ADDENDUM NO. 1  
SEWERAGE SYSTEM IMPROVEMENTS  
CONTRACT 16-01  
PEAK WASTEWATER FLOW DIVERSION  
PUMPING STATION MODIFICATIONS  
CLEVELAND UTILITIES  
CLEVELAND, TENNESSEE  
CU PROJECT NO. S2683X  
WAUFORD PROJECT NO. 4626

Date of Addendum: Wednesday, April 5, 2017

**TOP PLAN**  
SCALE: 3/8"=1'-0"

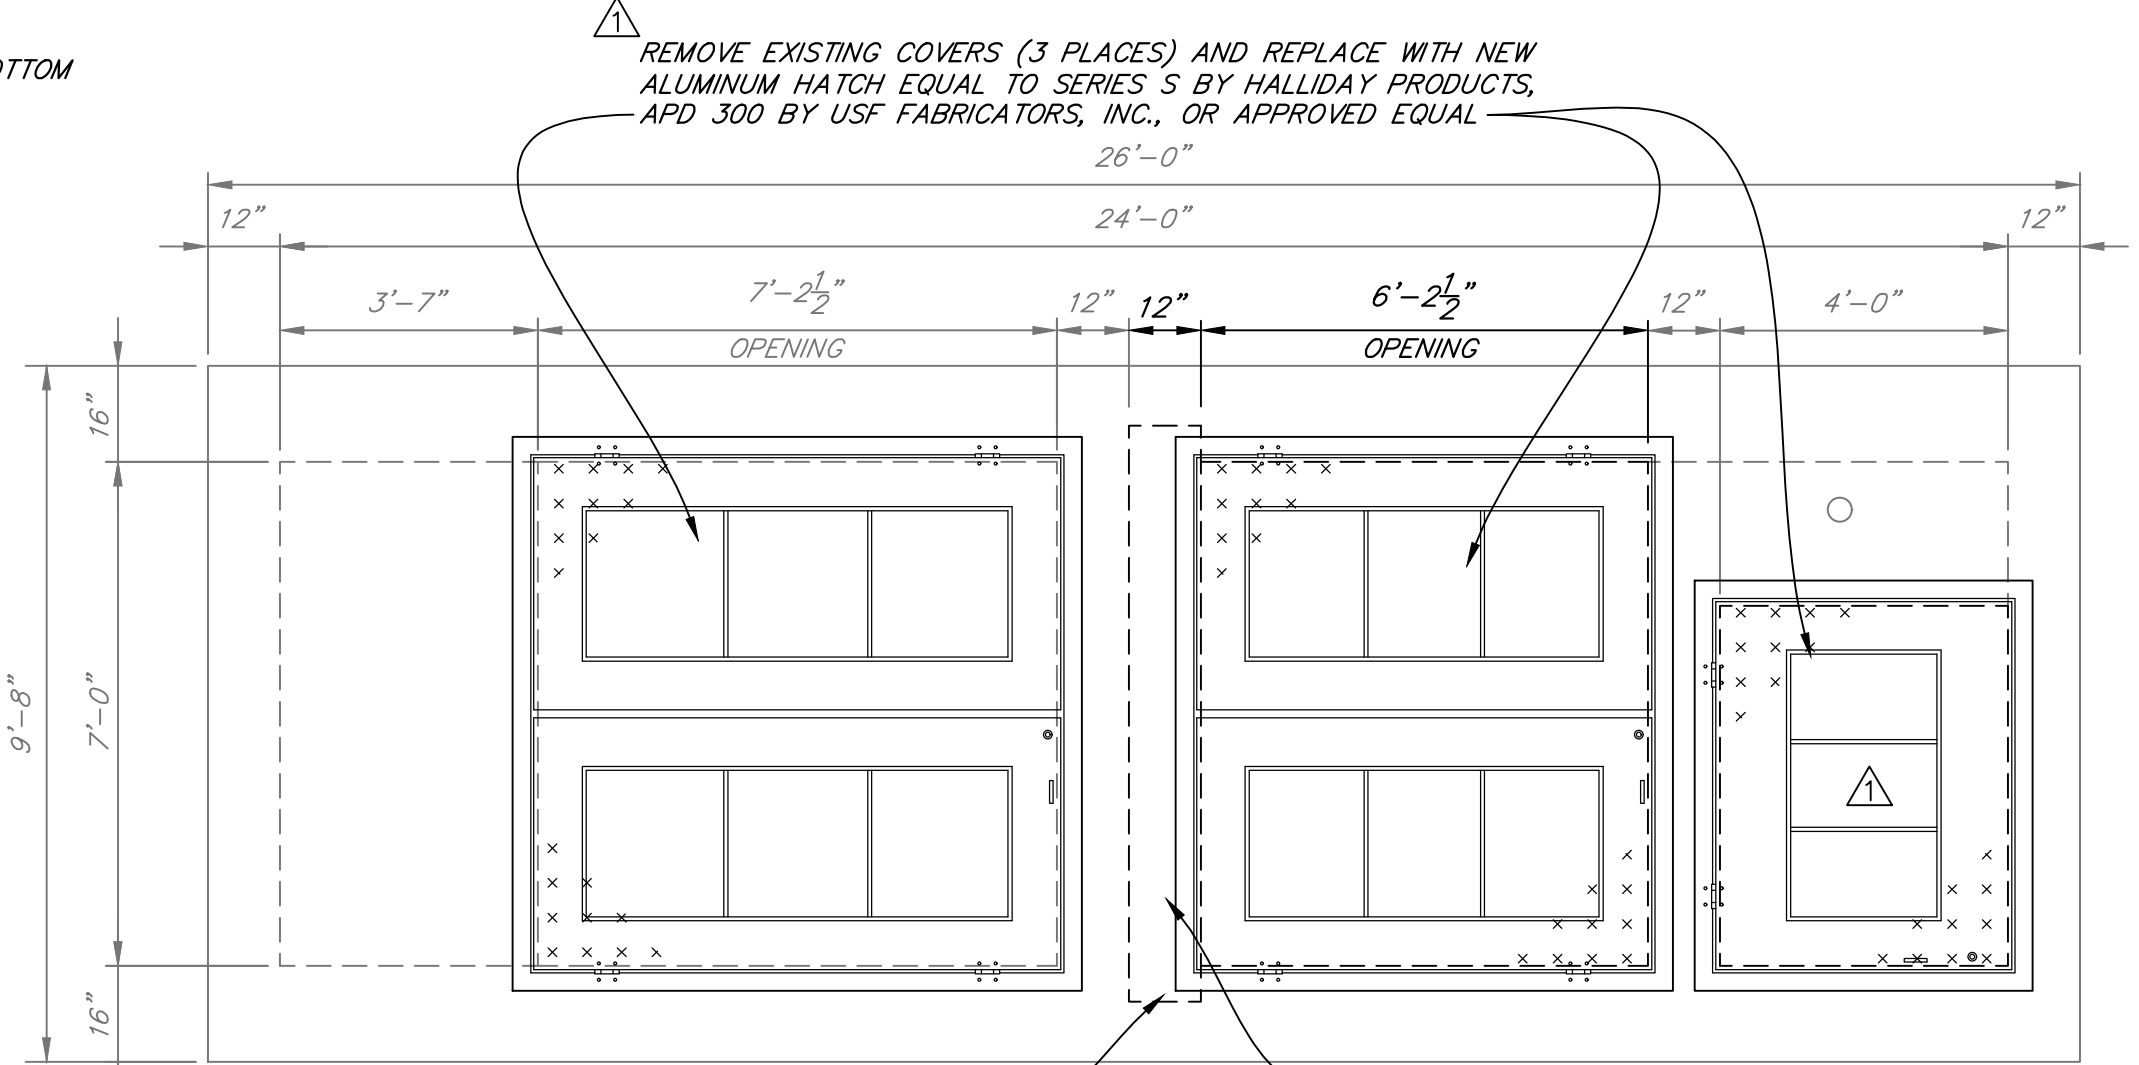
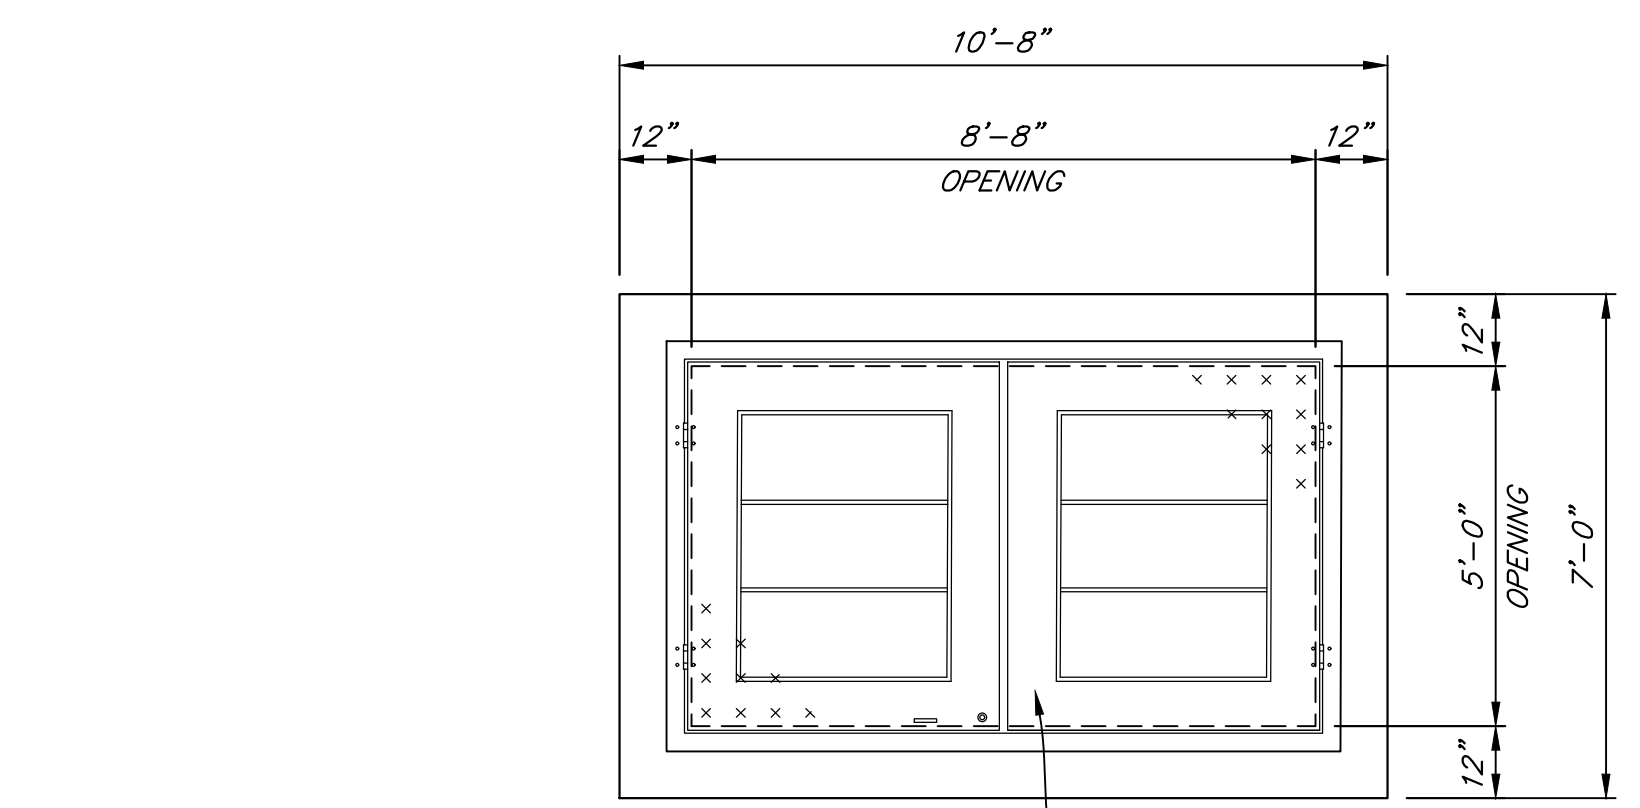
6. Plans, Sheet 1:  
Revise as shown on attached Plans, Sheet 1.
7. Plans, Sheet 2:  
Revise as shown on attached Plans, Sheet 2.
8. Plans, Sheet 3:  
Revise as shown on attached Plans, Sheet 3.
